DEVELOPMENT NO.:	24019750
APPLICANT:	JAM Constructions Pty Ltd Trading as James Michael Homes Pty Ltd
ADDRESS:	10 CROSBY ST SOUTH BRIGHTON SA 5048
NATURE OF DEVELOPMENT:	Construct a 2 Storey Dwelling, with retaining walls up to 1.6m
ZONING INFORMATION:	<p>Zones:</p> <ul style="list-style-type: none"> • General Neighbourhood <p>Overlays:</p> <ul style="list-style-type: none"> • Airport Building Heights (Regulated) • Affordable Housing • Prescribed Wells Area • Regulated and Significant Tree • Stormwater Management • Urban Tree Canopy
LODGEMENT DATE:	8 Jul 2024
RELEVANT AUTHORITY:	Assessment Panel at City of Holdfast Bay
PLANNING & DESIGN CODE VERSION:	P&D Code (in effect) Version 2024.12 04/07/2024
CATEGORY OF DEVELOPMENT:	Code Assessed - Performance Assessed
NOTIFICATION:	Yes
RECOMMENDING OFFICER:	Michael Gates Development Services (Planning and Building) Lead
REFERRALS STATUTORY:	None
REFERRALS NON-STATUTORY:	None

This application is for the construction of a two-storey detached dwelling, retaining walls and fences. The dwelling has the garage located on the southern boundary on top of a 1.3 high retaining wall. The dwelling comprises 4 bedrooms, an office, two living areas, a te

Image showing the upper level

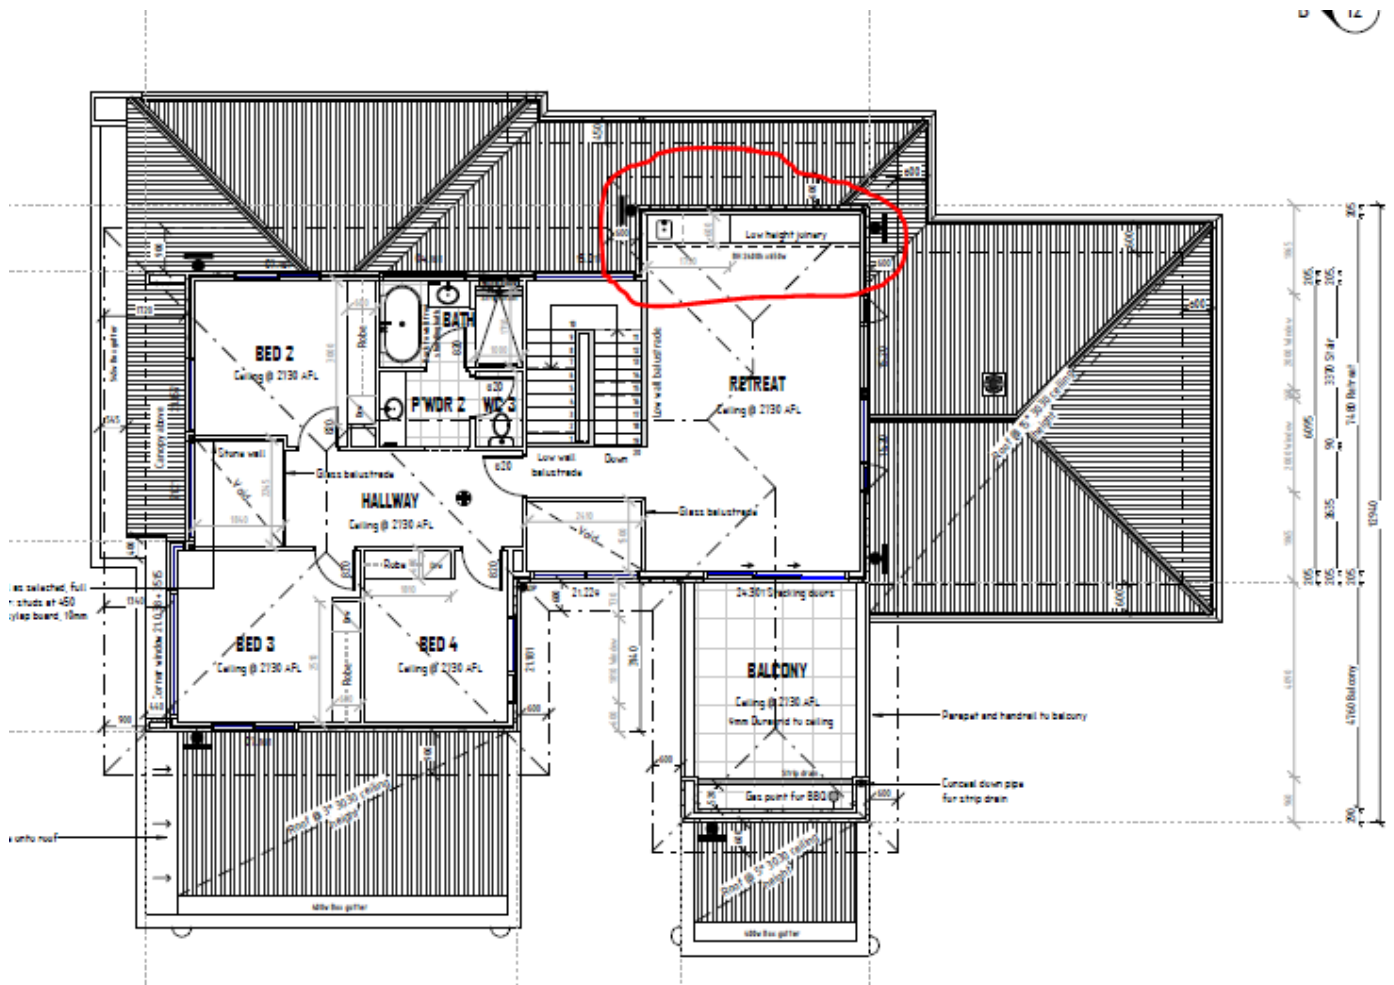
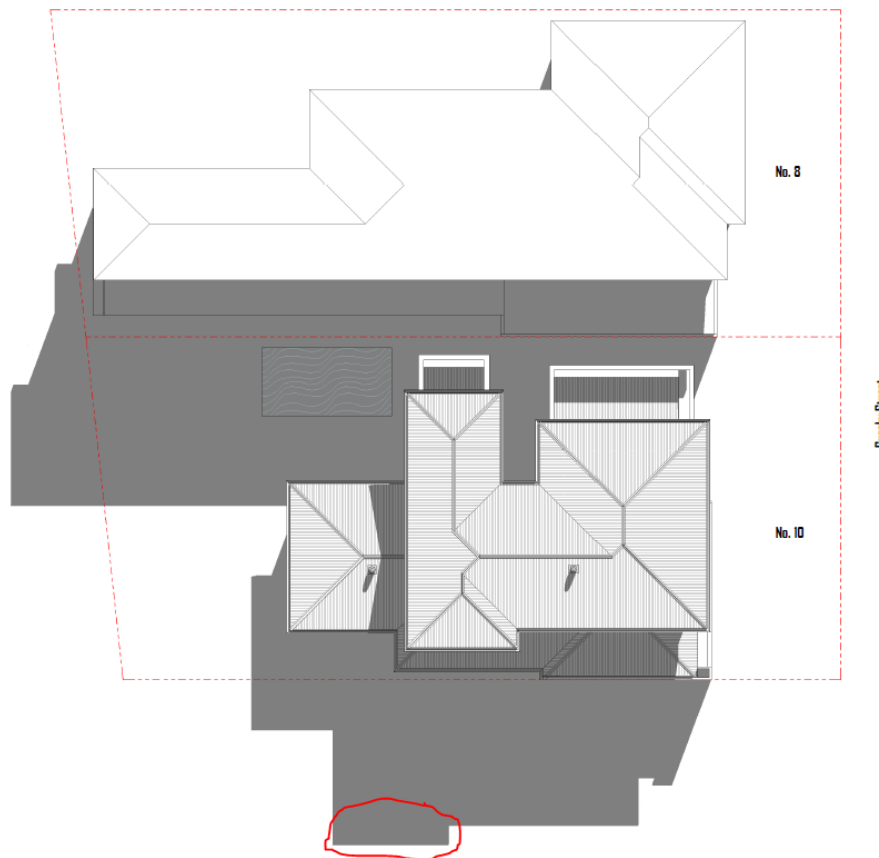
The proposal satisfies all of the Desired Performance Features requirements in regards to setbacks except for a small portion of the upper level on the southern side. The front setback, rear setback and side setbacks will all complement the existing setback patterns. The large rear setback provides a large amount of private open space and separation between the neighbouring dwellings.

Most of the upper storey is set 3.8 metres from the southern boundary, with a small section set 2.4 metres, with the area circled in red below.

Over shadowing diagram of the proposed dwelling

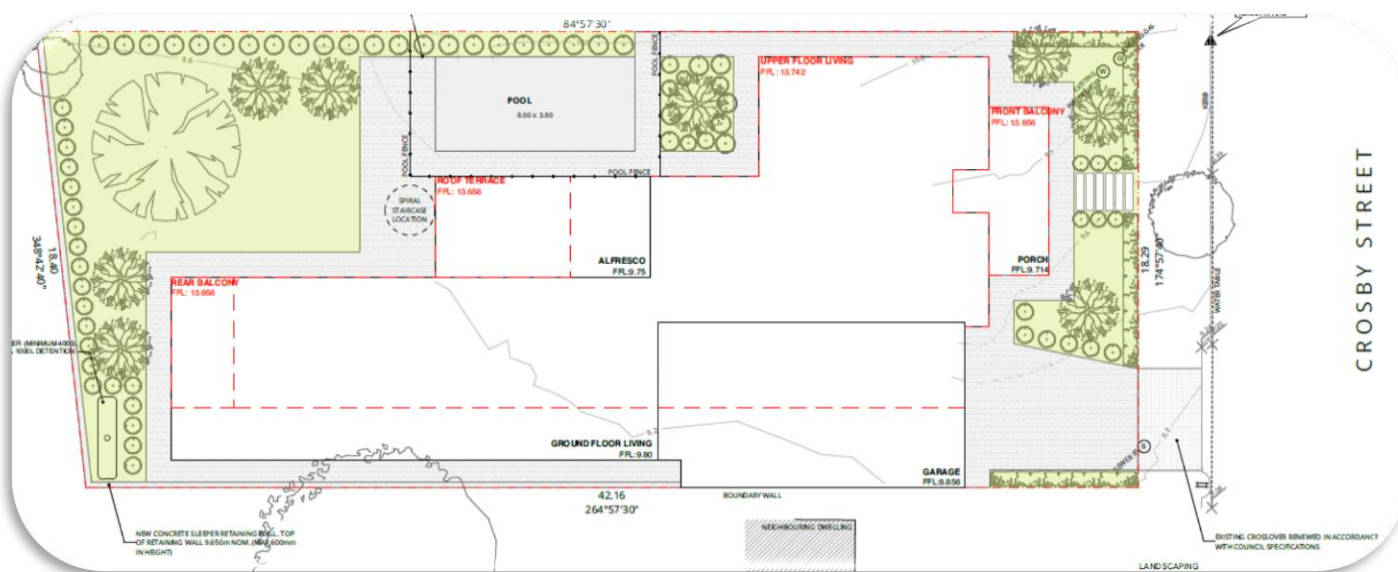
The applicant has provided an overshadowing diagram which demonstrates there is little difference in overshadowing between the area that has a compliant setback, and the area which has a shortfall. The proposed area that protrudes closer to the boundary is considered not to be visually dominate, and given the limited additional overshadowing, is considered reasonable in this instance.

The image below has the shadow caused by the protruding upper storey area circled in red. This diagram shows the additional overshadowing is of a minor difference.

Site plan of the adjacent dwelling to the north showing no areas of private open space visible from the south

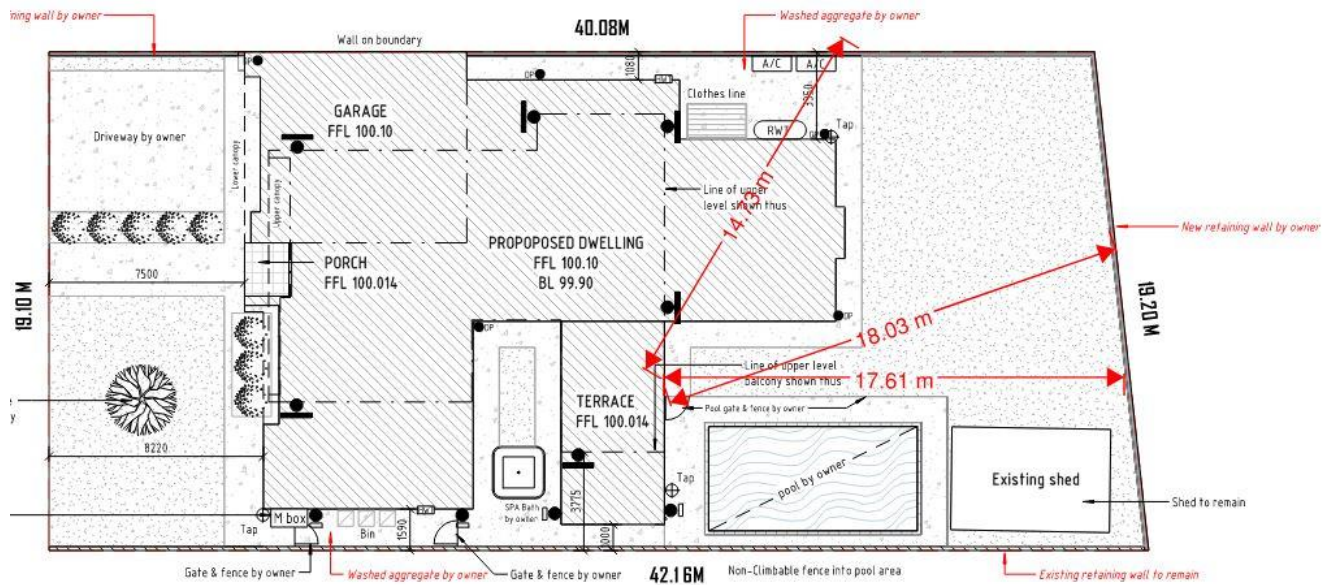
The proposal includes an upper-level balcony on the northern side of the dwelling that does not include screening. The design is considered reasonable in this instance given there will be no direct overlooking to the north due to the orientation of the dwelling to the north and western boundary is located more than 15 metres away. As outlined in Code, privacy measures are not required for private open space areas more than 15 metres away. A site plan of the neighbouring property to the north is shown below demonstrating the balcony will not overlook the adjacent dwelling.

A standard condition is included in the recommendation in regards to window treatment to maintain privacy to neighbouring properties as there are upper storey windows that may overlook adjacent dwellings at the rear of the upper level.
